June 2023

Sydney Metro West

Sydney Olympic Park Over and Adjacent Station
Development

Addendum to Appendix T - Transport and Access
Report

Figure 2.1: Existing AM peak hour pedestrian counts (March 2021)

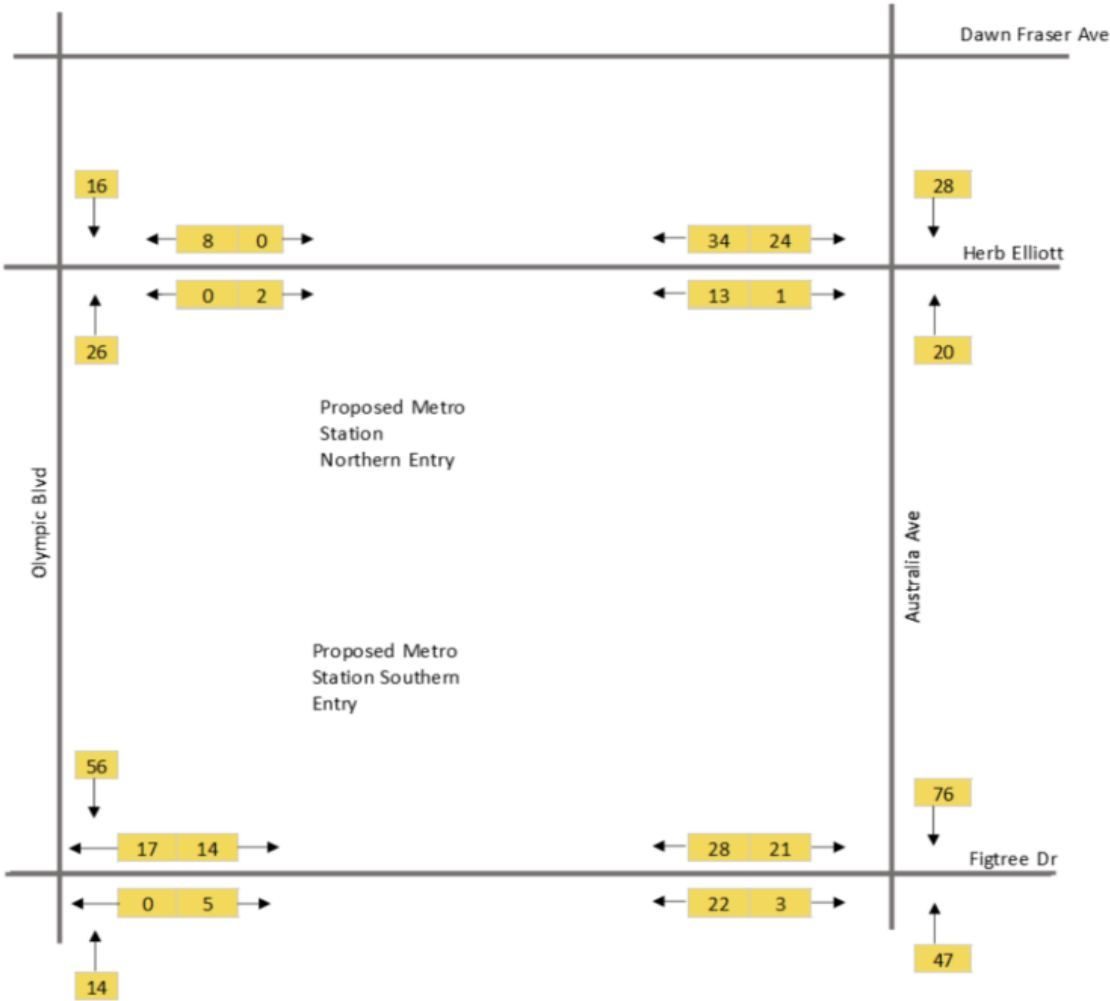
Clarify whether pedestrian counts, which were collected in March 2021, factored-in any Covid-19 reduction, similar to the reduction factored into the vehicle traffic counts. A similar methodology should be used to ensure consistency.

No COVID adjustments were made to AM and PM Peak observed pedestrian flows at Sydney Olympic Park (SOP) as recorded movements at intersections were significantly low and adjustments would have had negligible impacts on the total recorded pedestrian movements, as can be seen in Figure 2.1 from the EIS Transport and Access Report.

Whilst the pedestrian network in SOP is well established, with large, wide paved footpaths, overall demand outside of events is significantly low. A COVID adjustment was factored into traffic counts as travel by vehicle was found to be overwhelmingly the preferred mode of transport to / from the area, accounting for 69% of all inbound and 56% of outbound trips in AM peak. Therefore the numbers recorded for vehicle traffic counts were significantly higher.

Figure 2.2: Building 1 access to / from car park

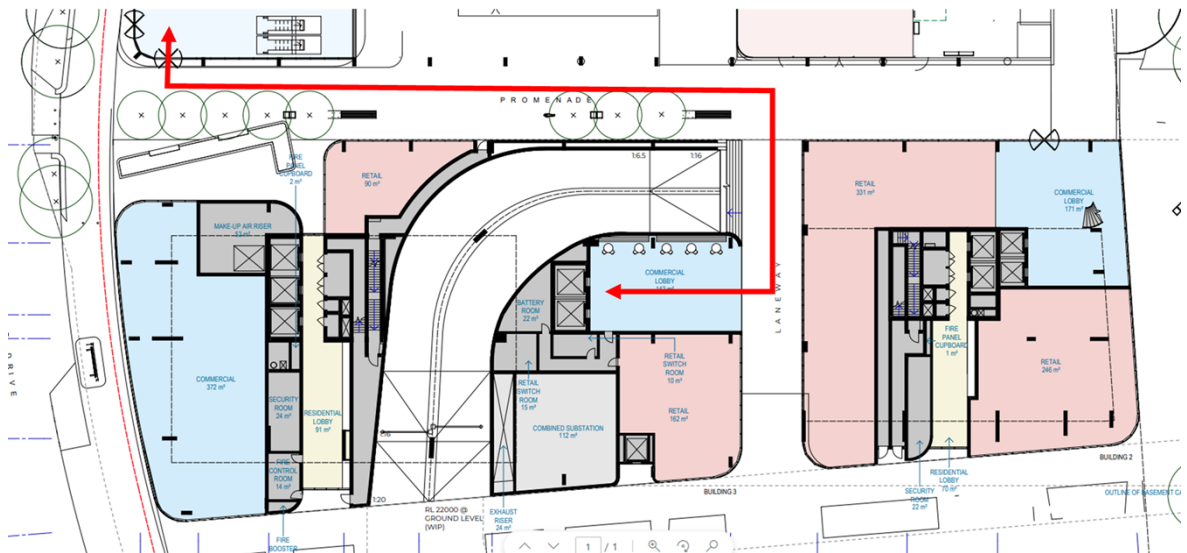
- *accessible parking including consideration for accessible access between the basement and the commercial land use at Building 1*
- *car-share and motorcycle parking*
- *appropriate loading facilities, including options for alternative loading locations to ensure they meet service levels and/or include the consideration of a loading facilities management plan.*

Table 2.2 states the provision of accessible parking will be a minimum of 2% of the car parking provision. The indicative location of these spaces is shown in the indicative Reference Scheme drawings. The lift access from the basement car park below Buildings 2 and 3 is close to the entry to the Building 1 commercial OSD and is step-free, as shown by the red arrow in Figure 2.2 below.
